ADDENDUM NO. 7

DATE: March 22, 2021
FROM: City of Grand Junction Purchasing Division
TO: All Offerors
RE: Grand Junction Fire Department Fire Station #3 Construction IFB-4889-21-DH

1 LANDSCAPE PLAN

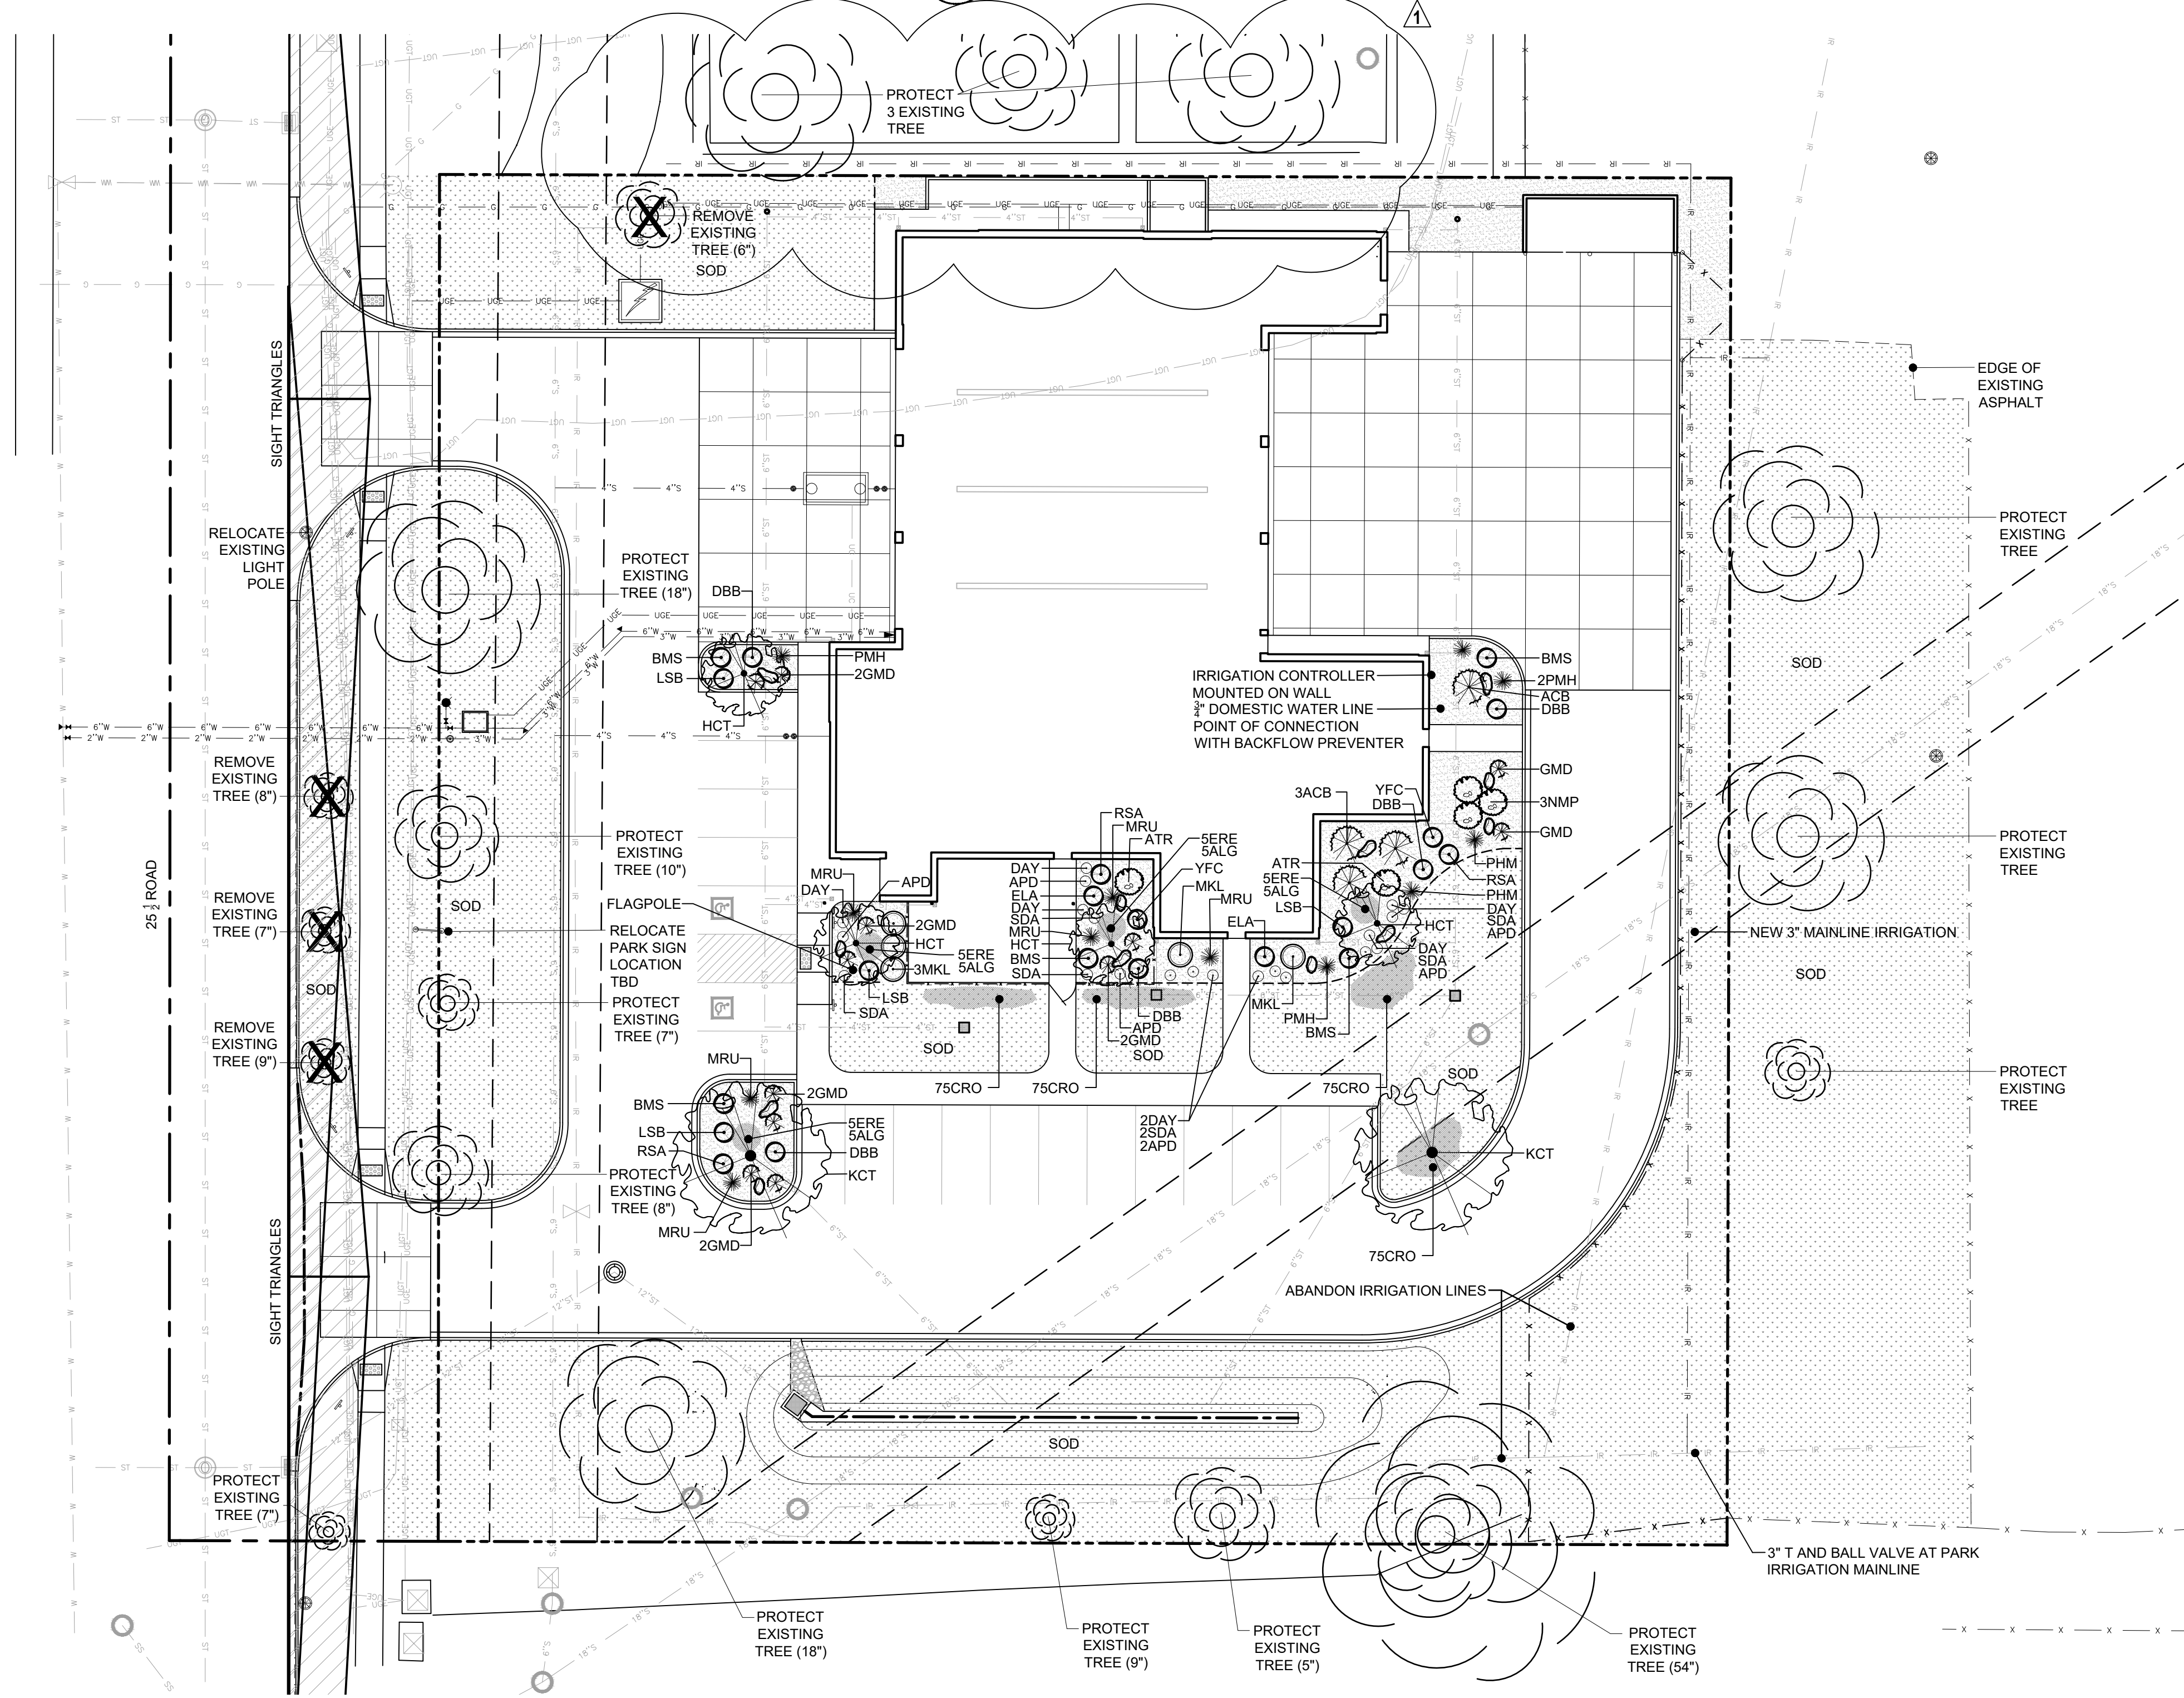
- A. The awarded contractor shall work with their construction surveyor to establish horizontal and vertical control that works for them.
13. Turf Sod: Is all the turf sod on the drawing to be quoted new sod??

- A. Yes, all turf areas on the landscape plan are to be new sod.
14. Crocus Planting Areas: Are the Crocus planting areas in the sod areas to be void of sod? Is there to be a mulch top dressing?

- A. The crocus bulbs are to be planted in the ground under the sod. No mulch is needed.
15. Trees: Is a fall dig for trees acceptable, after Nov. 1st, 2021?
